Planning Commission

Staff Report

Case No:	17DEVPLAN1140
Project Name:	Primrose School
Location:	14801 Bush Farm Road
Owner(s):	Papa Oreo DS, LLC
Applicant:	Primrose School Franchising, Co.
Representative(s):	Land Design & Development, Inc.
Project Area/Size:	1.9 acres
Jurisdiction:	Louisville Metro
Council District:	19 – Julie Denton
Case Manager:	Joel P. Dock, Planner II

- **Revised Detailed District Development Plan** for 12,300 square foot daycare center
- **Amendment to Binding Element** of the district development plan to eliminate binding element #2 related to maximum square footage
- **Landscape Plan** per binding elements

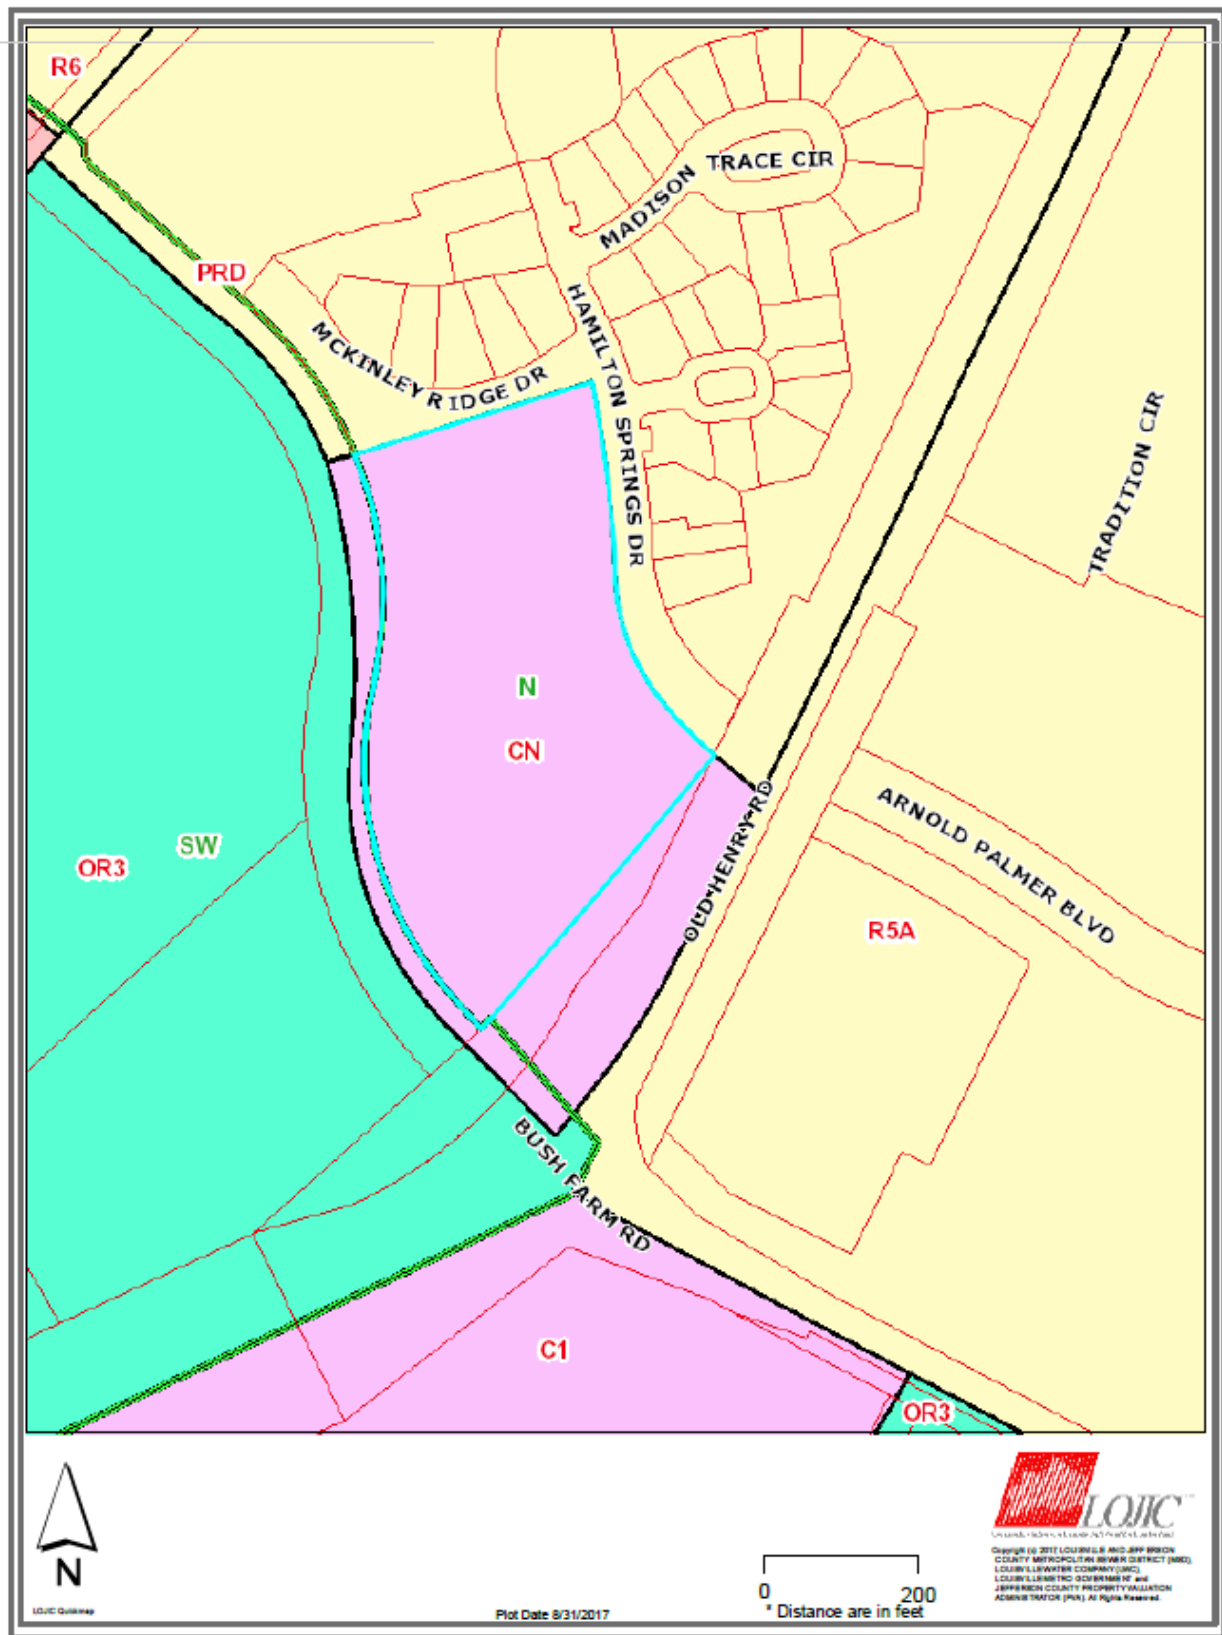
The proposed revised development plan increases the square footage of the building to 12,300 square feet and decreases the number of parking spaces to forty from the previously approved development plan of case 16ZONE1042. In accordance with the approved binding elements, the aforementioned requests are being brought before the full body of the Planning Commission for review and approval. The requested deletion of binding element #2 will allow future deviations from the maximum square footage without review by the full body of the Planning Commission, similarly to standard revised development plan procedures.

The revised detailed district development plan and amendment to binding element #2 of the district development plan appear to be adequately justified based on the standard of review and staff analysis beginning on page 2 of this staff report. Planning and Design Services landscape architect has reviewed the landscape plan and finds that it meets or exceeds the minimum requirements of chapter 10 of the Land Development Code and is compliant with binding elements 9 & 10.

The landscape plan has been reviewed by staff and it has been found to be in compliance with applicable regulations and binding elements.
